SPEEDWAY #2224 JSP17-63 with PRO Rezoning 18.720

SPEEDWAY #2224 JSP 17-63 AND ZONING MAP AMENDMENT 18.720

PLAN REVIEW CENTER REPORT

Rezoning Request from OST (Office Service Technology) & B-3 (General Business) to B-3 (General Business) with Planned Rezoning Overlay (PRO) – Second Revised Concept Plan

FRONT ELEVATION

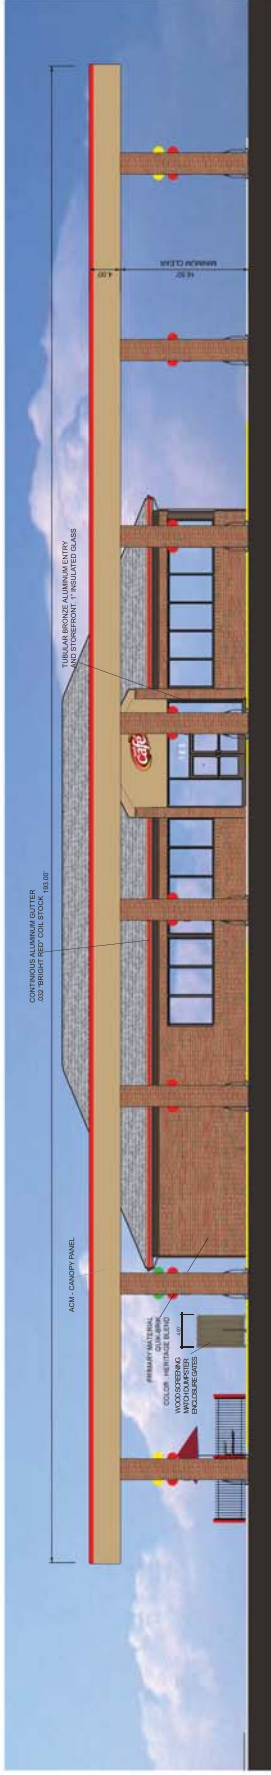
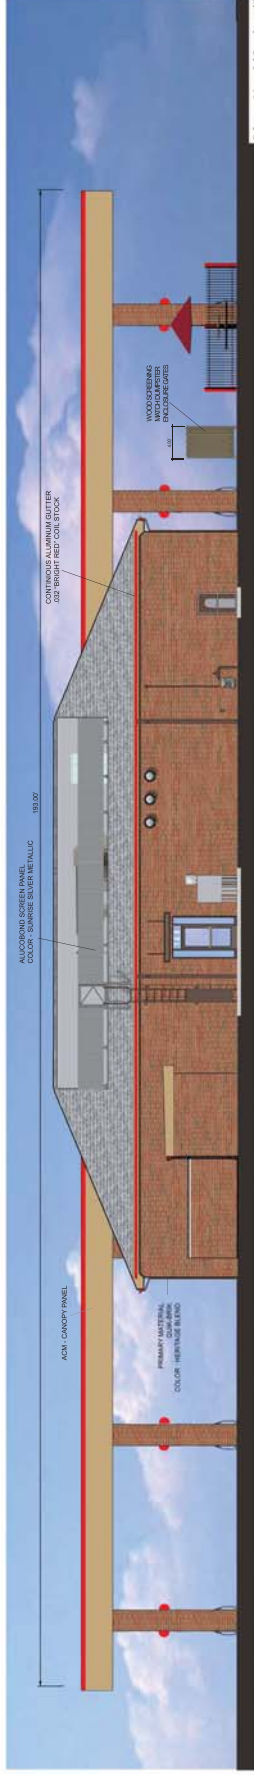
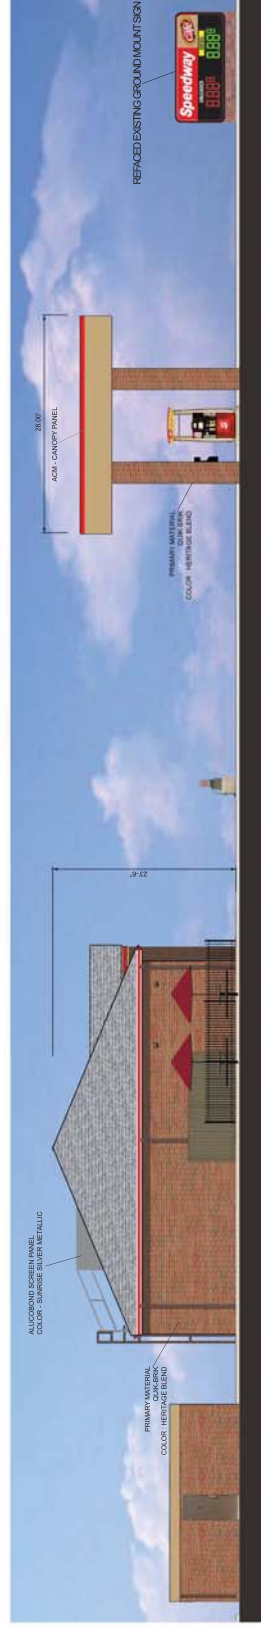
- c. Section 9 Façade Waiver for the overage of Asphalt Shingles (maximum 25%; proposed 50% on east, 35% on south, 40% on north) on the building.
 - d. Section 9 Façade Waiver for the exceeding the percentage of flat metal panels on the fuel canopy, because the canopy consists of the maximum percentage of brick feasible due to relative proportions of the columns to fascia;
